Typical details: where CAD and Revit draw the same detail differently

55 of the 190 CAD typical details have a Revit version in your templates that is drawn differently.

Compared by eye on 2026-10-23 from Nelson's CAD blocks and the Concrete Tower R24 / Steel R24 / Container R23 templates.

Revit: 1E1.04_13_TYPICAL DOWNTURN (Kor_Concrete_Tower_Project_Template_Arch D E1 E_R24 (Do Not ; on 1E1.04 TYPICAL DETAILS)

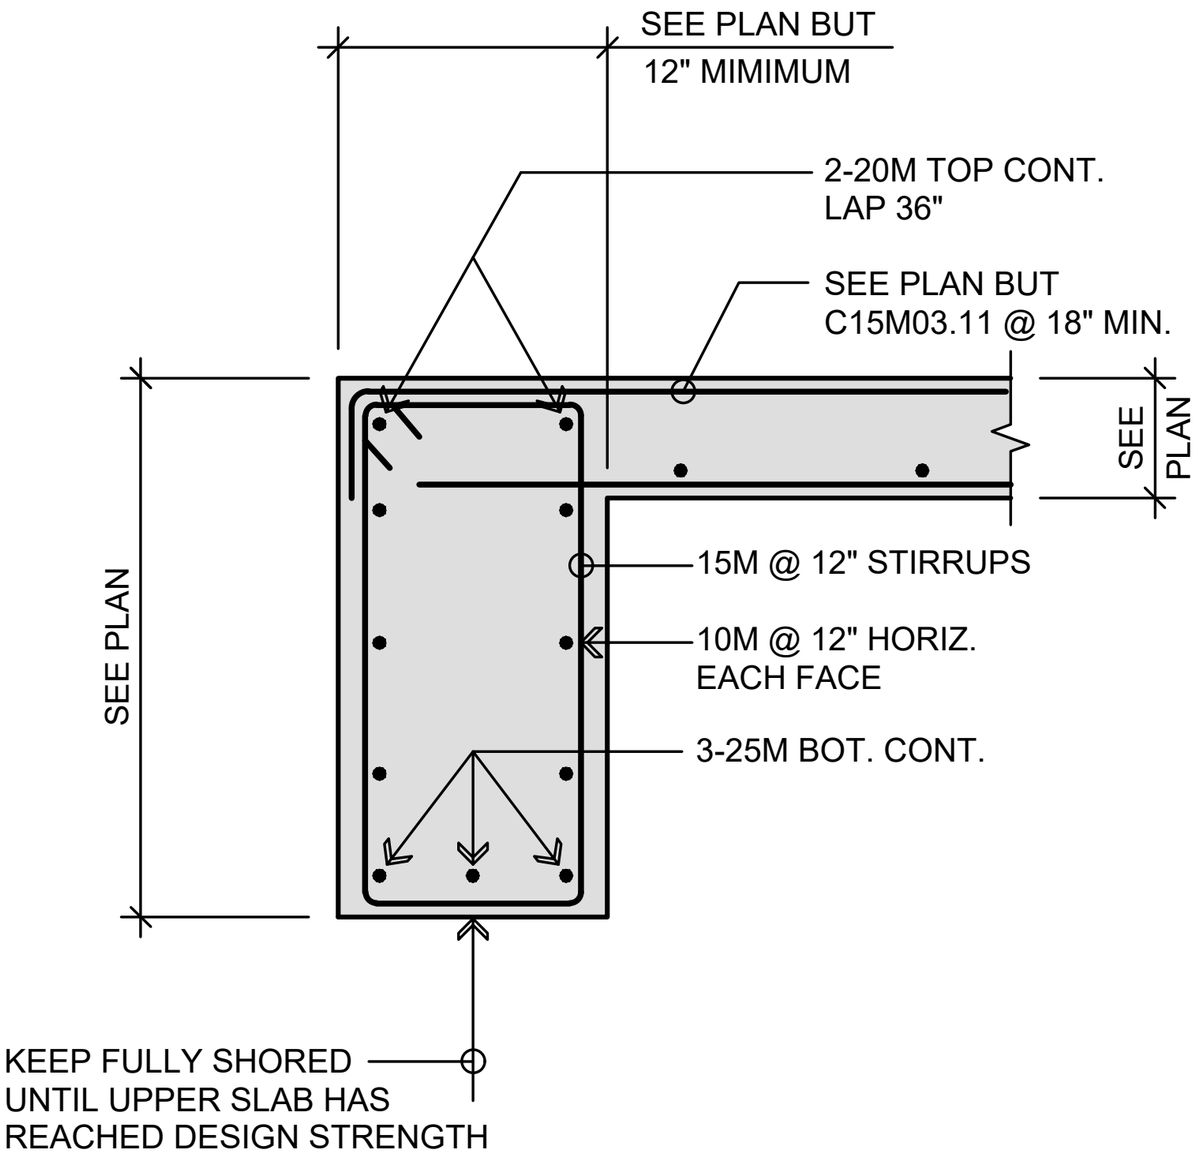
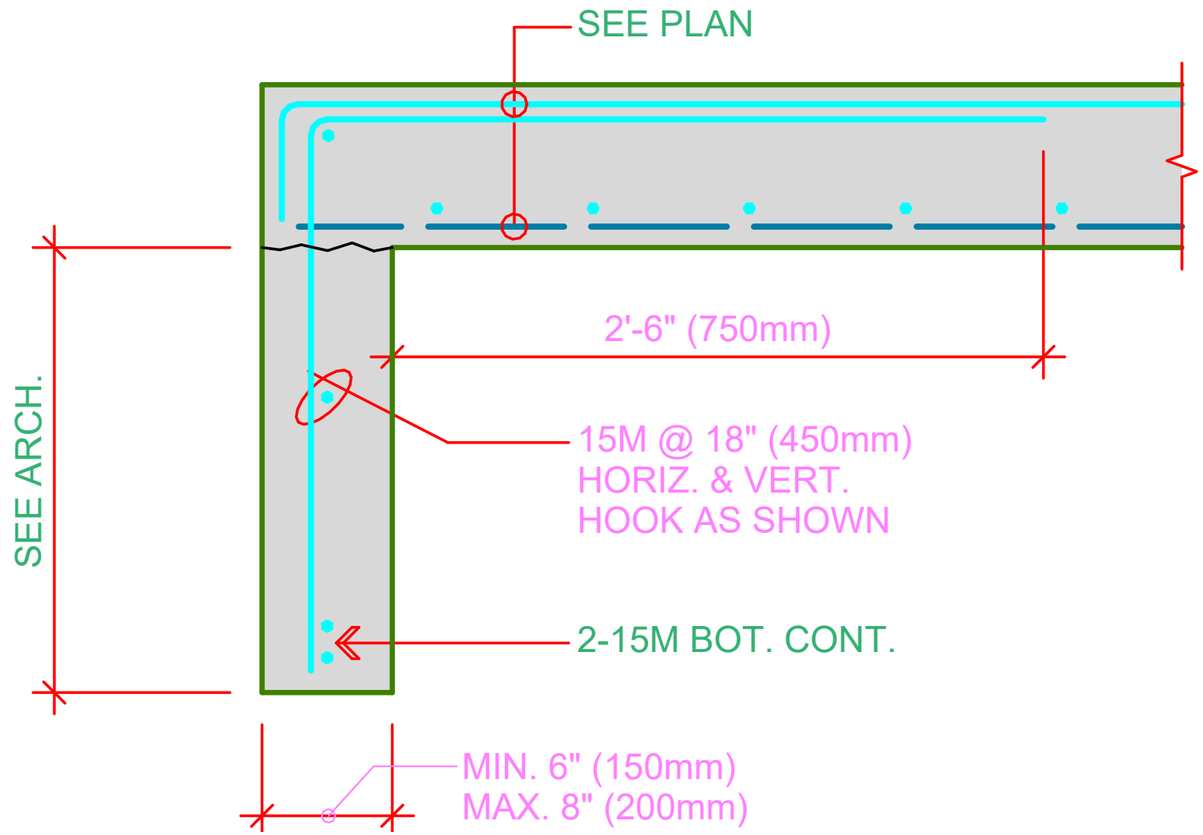
What differs: CAD is a stirruped downturn beam (3-25M bot, keep shored); '1E1.04_13_TYPICAL DOWNTURN' is a plain thin downturn wall.

Revit: 1E1.04_13_TYPICAL DOWNTURN (Kor_Concrete_Tower_Project_Template_Arch D E1 E_R24 (Do Not ; on 1E1.04 TYPICAL DETAILS)

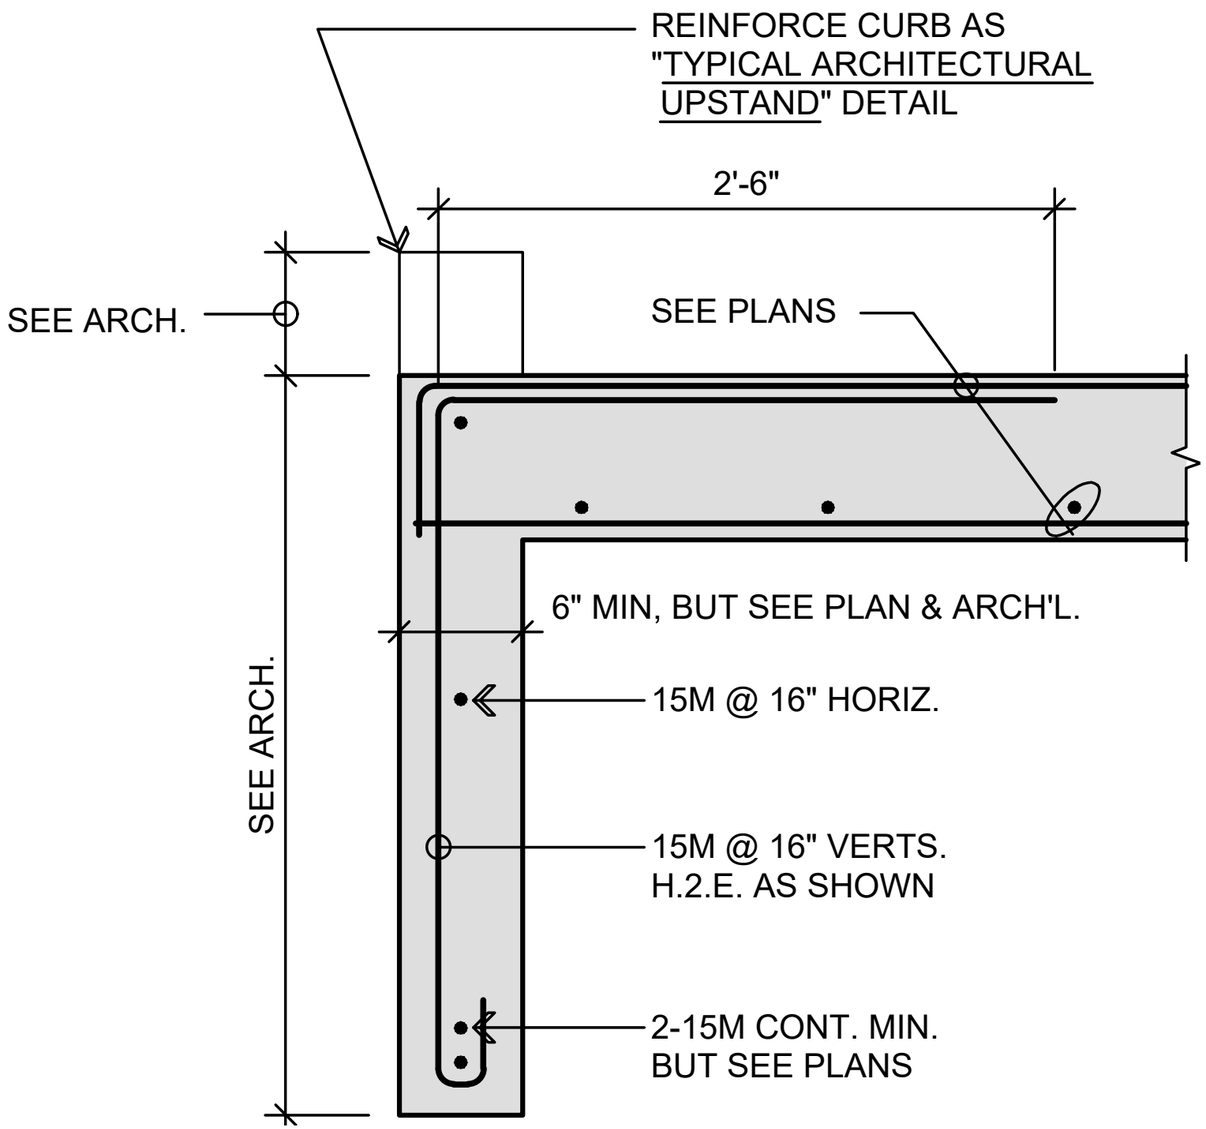
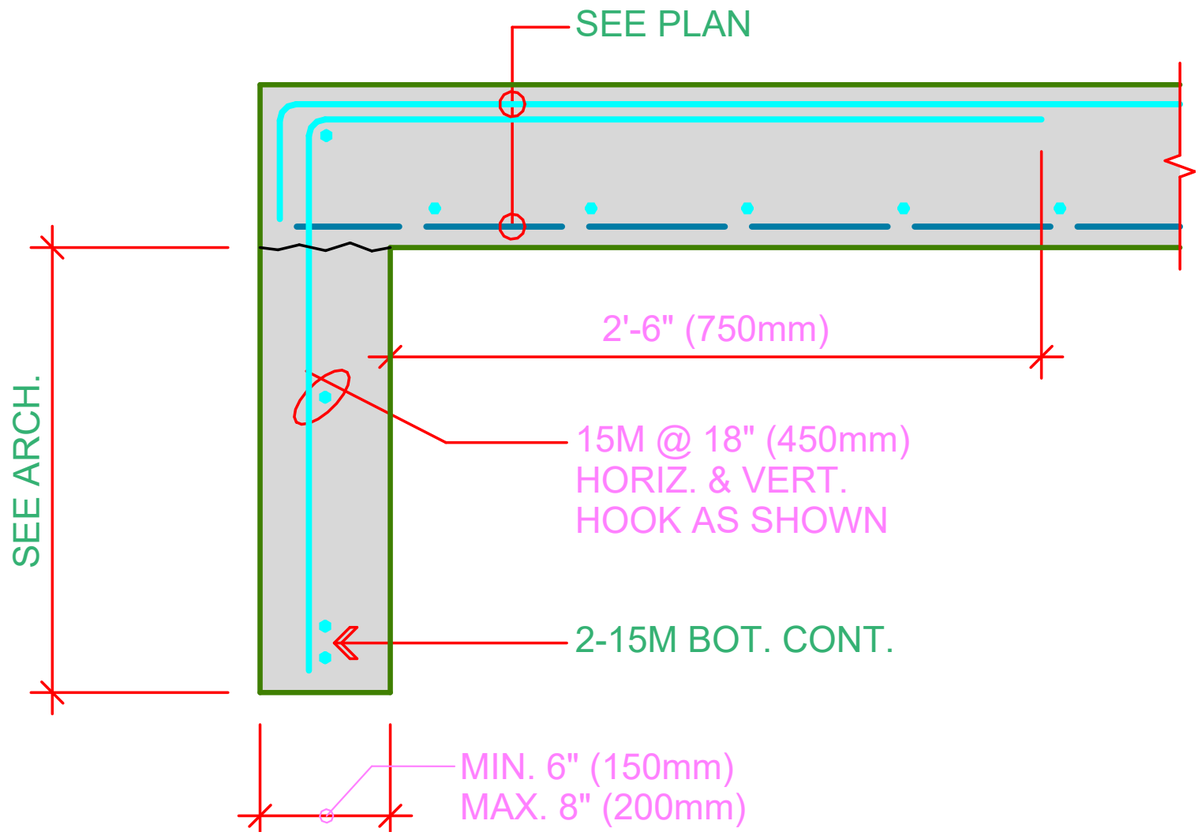
What differs: Closest match: same 2'-6in downturn with 2-15M bot cont, but the CAD has 15M @ 16in horiz/vert where '1E1.04_13_TYPICAL DOWNTURN' has 15M @ 18in, plus a curb/upstand callout.

CAD: KOR-D505-DET 03 - FOLDING PANEL HANGER DETAIL

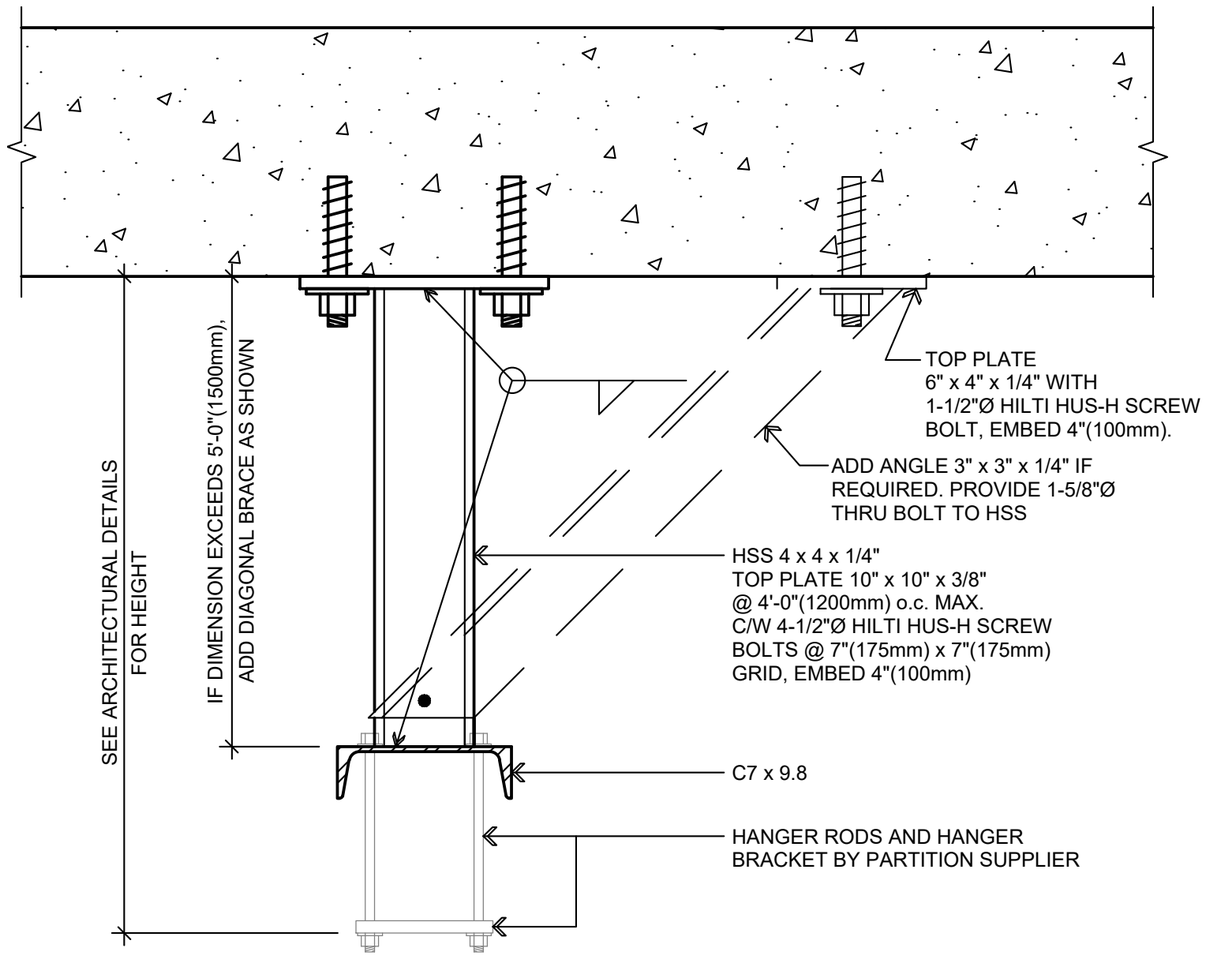
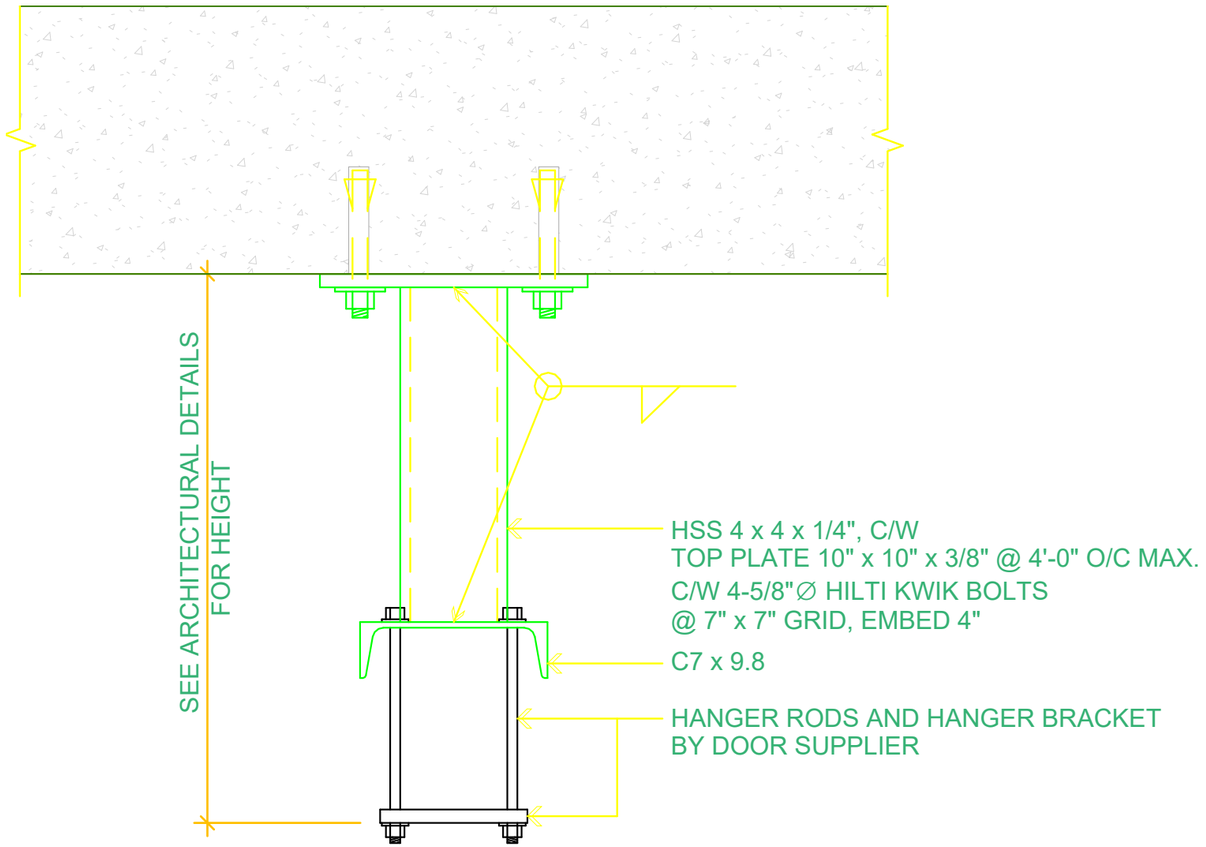
What differs: Same folding panel hanger, but the CAD adds a diagonal angle brace and uses Hilti HUS-H screws @ 6ft for a 15 psf door; 'D5.01_12_FOLDING PANEL HANGER DETAIL' has Kwik bolts @ 4ft for 20 psf and no brace.

CAD: KOR-S302-DET 07 - TYPICAL WALL AND ZONE VERT REINFORCING DETAIL THICKNESS CHANGES

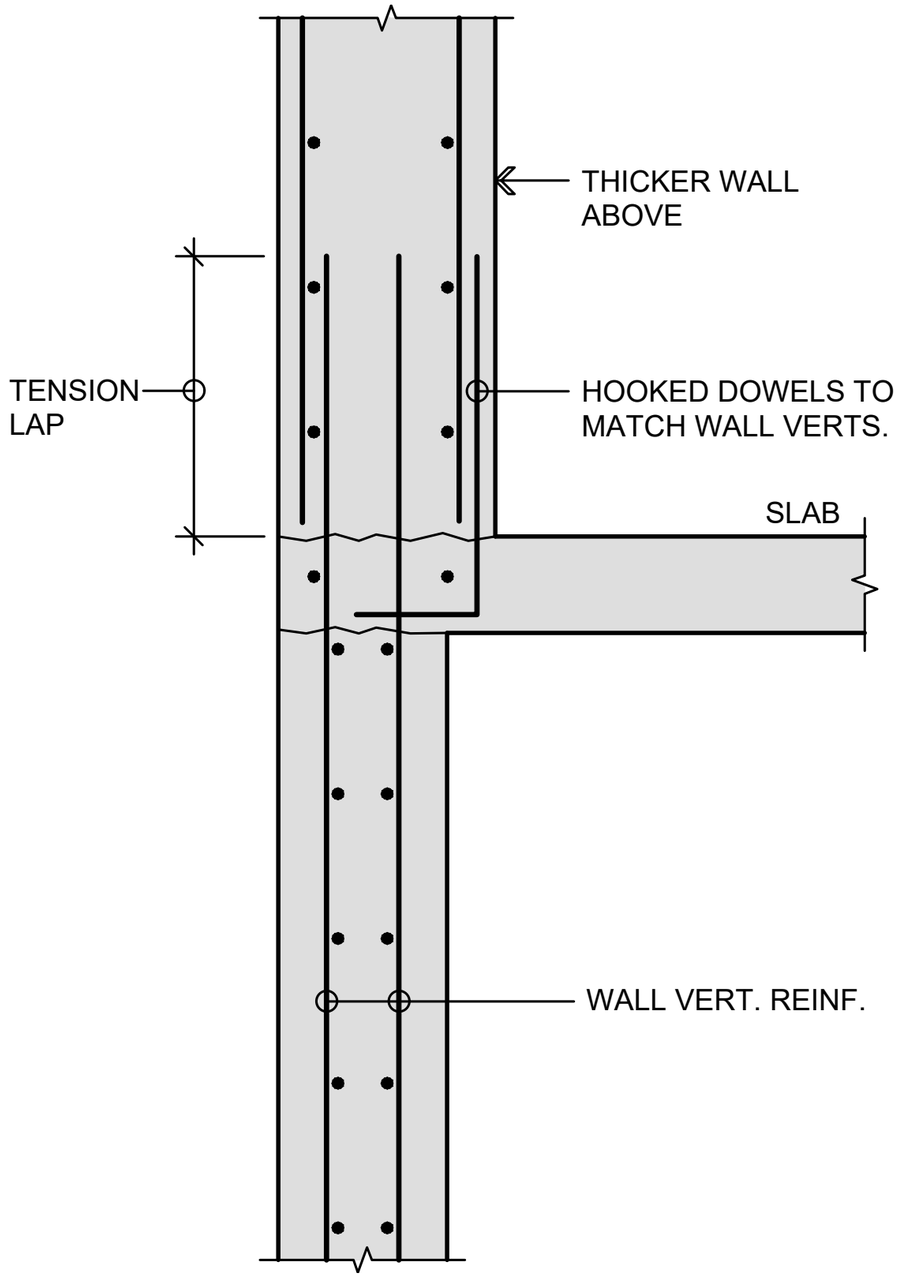
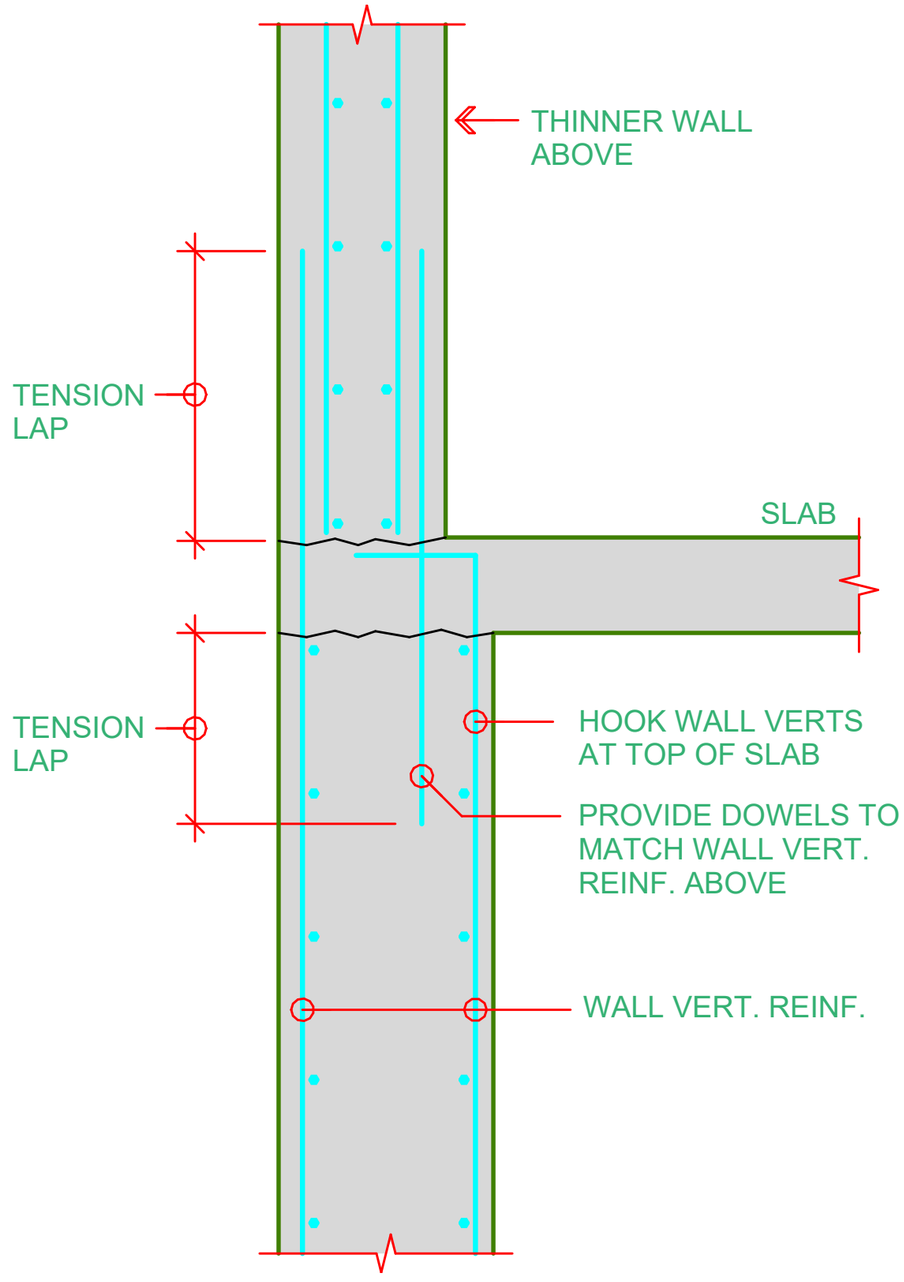
What differs: CAD is the THICKER-wall-above case with hooked dowels to match the wall verts and one tension lap; '1E3.05_6_TYPICAL WALL AND ZONE VERT REINFORCING DETAIL WHERE WALL THICKNESS CHANGES'/'D3.05_6_TYPICAL WALL AND ZONE VERT. REINFORCING DETAIL WHERE WALL THICKNESS CHANGES' are the thinner-wall-above case.

53 of 55 CAD: KOR-S302-DET 12 - TYPICAL DIAGONALLY REINFORCED HEADER DETAIL

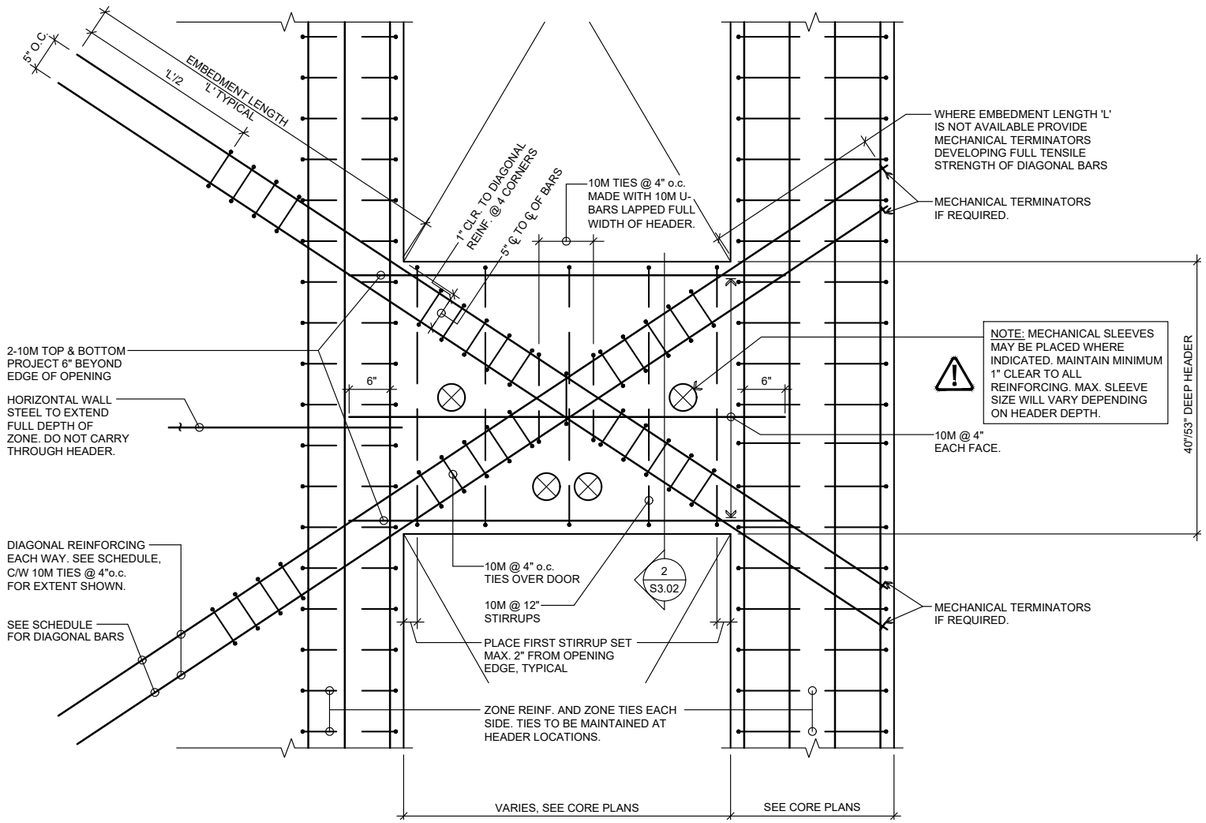
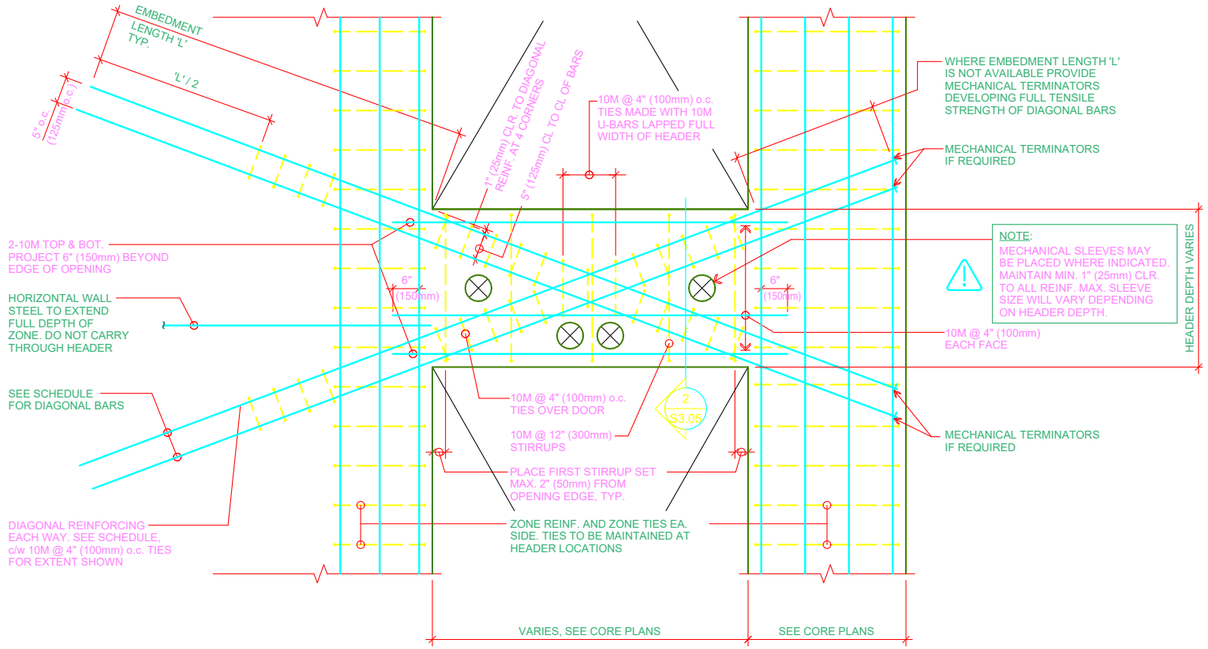
What differs: CAD is a larger, project-specific 40in/53in deep header elevation with mechanical terminators and sleeve notes and no embedment tables; '1E3.05_1_TYPICAL DIAGONALLY REINFORCED HEADER DETAIL' is the generic version with tables.
